# Service Interfaces & Physical Instantiations

John D'Ambrosia, Force10 Networks  
David Law, 3COM  
Steve Trowbridge, Alcatel-Lucent  
Mark Gustlin, Cisco  
Ilango Ganga, Intel

# Introduction

# Generic multi-lane abstract service interface

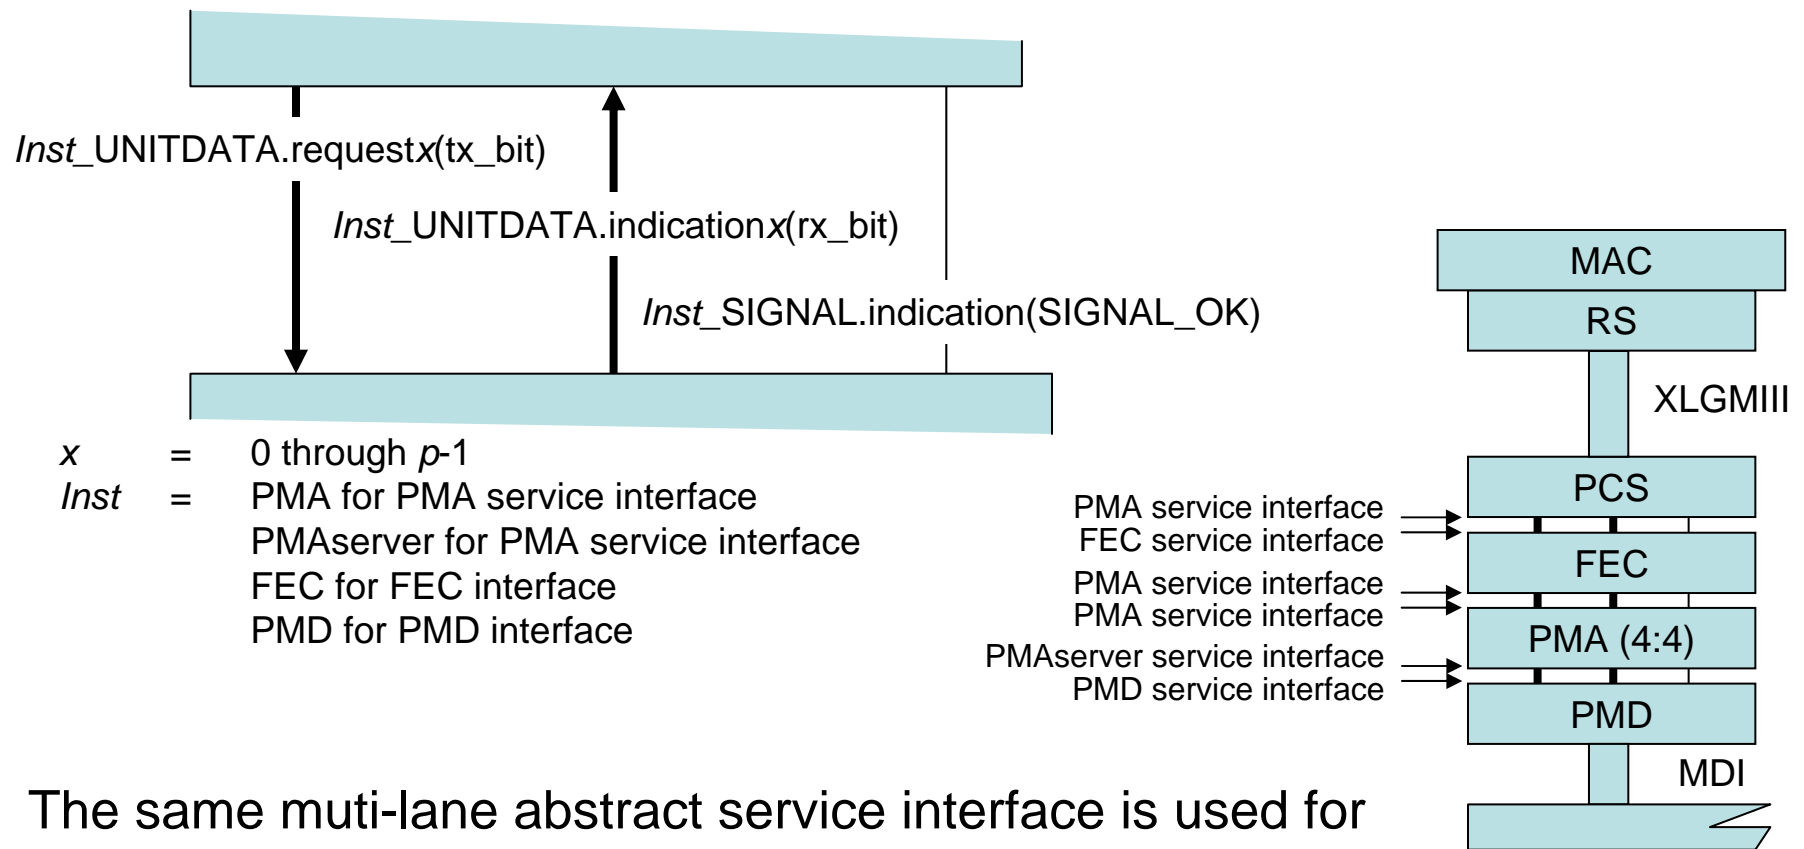
The same multi-lane abstract service interface is used for the PMA, PMAserver, FEC and PMD service interfaces supporting a flexible architecture with optional FEC and multiple PMA sublayers

1. A single scalable generic multi-lane abstract service interface is used for the PMA, PMAserver, FEC and PMD service interfaces supporting a flexible architecture with optional FEC and multiple PMA sublayers (include figures from page 4)

- Add change as recommended on Page 8
    - Add a diagram (similar to Page 4 of this presentation) that illustrates a nAUI between two PMA sublayers with PMA SERVICE INTERFACES illustrated coming out of the top / bottom of the PMA sublayers not connected to the nAUI

# nAUI - Architectural Perspective

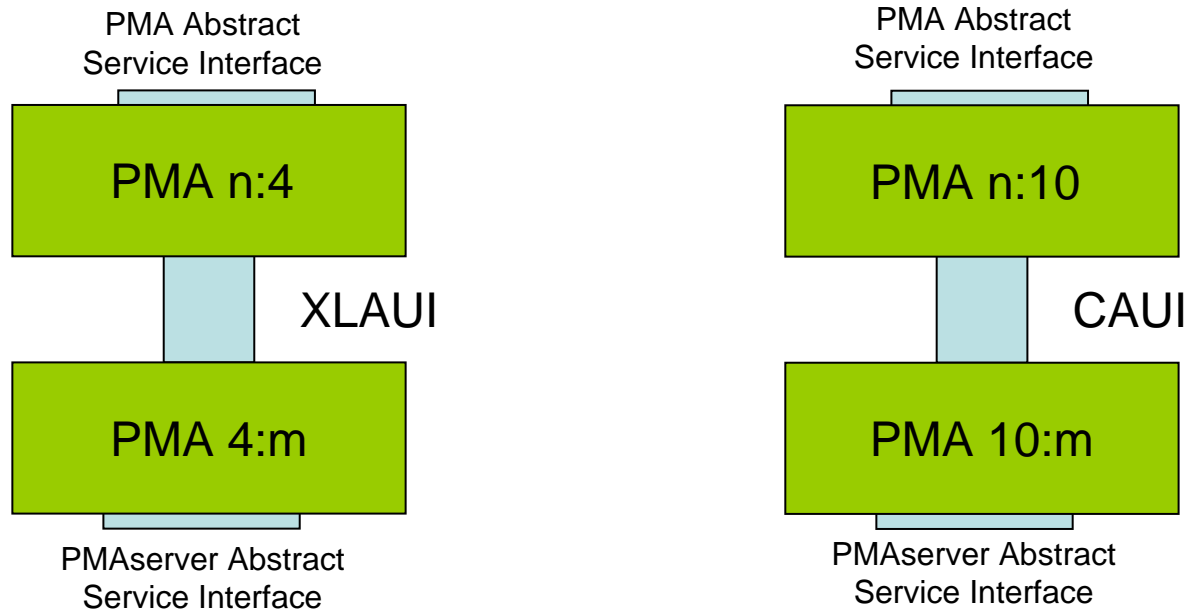
- nAUI is a physical instantiation of the connection between two adjacent PMA sublayers
  - XLAUI is a 10 Gb/s by 4 lane physical instantiation of the respective 40 Gb/s connection
  - CAUI is a 10 Gb/s by 10 lane physical instantiation of the respective 100 Gb/s connection
- Number of lanes above/below matched by adjusting the 'n' and 'm' values.
  - For connecting to PCS and FEC sub-layers : 4 lanes at 40Gb/s and 20 lanes at 100Gb/s
  - For PMA and PMD sub-layers: implementation dependent
- Optional testability for the nAUI via the inclusion of PMA sub-layers
- Retiming in the Rx path via the inclusion of the PMA sub-layer

2. nAUI is a physical instantiation of the connection between two adjacent PMA sublayers (include figures from Page 5)
  - a. As a physical instantiation it defines electrical and timing specification as well as a requiring a receive re-timing function.

- Under 83.5.5, add sub-clause that architecturally defines nAUI as a retimed interface
    - nAUI is a physical instantiation of the connection between two adjacent PMA sub-layers

Figure 83-5—PMA Functional Block Diagram

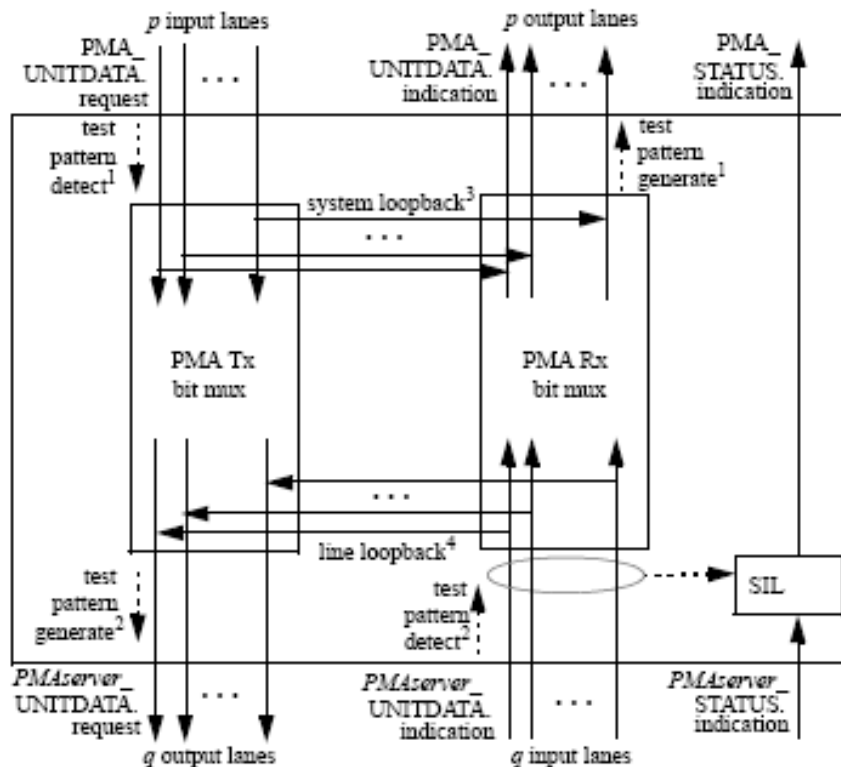
- Tx / Rx Path
- Bit Muxing
- Adjustment of interface width (primarily today for 100GbE)
  - PCSL to Physical (PCS / PMA: 20 to 10)
  - Physical to PCSL (PMA/FEC: 10 to 20)
  - Physical to Physical (PMA/PMA, PMA/PMD 10 to 4)
- Link status
- Optional Test Pattern Generation (note 1)
- Optional Test Pattern Detection (note 2)
- Optional System Loopback (note 3)
- Optional Line Loopback (note 4)

<sup>1</sup> If physically instantiated interface (XLAUI/CAUI) immediately above this PMA  
<sup>2</sup> If physically instantiated interface (XLAUI/CAUI or PMD service interface) immediately below this PMA, or if this is the closest PMA to the PMD  
<sup>3</sup> If this is the closest PMA to the PCS  
<sup>4</sup> If this is the closest PMA to the PMD

4. Opportunities for optional test pattern generation, optional test pattern detection, optional system loopback and optional line loopback are dependent upon the location of the PMA sublayer in the implementation. See figure 83-5
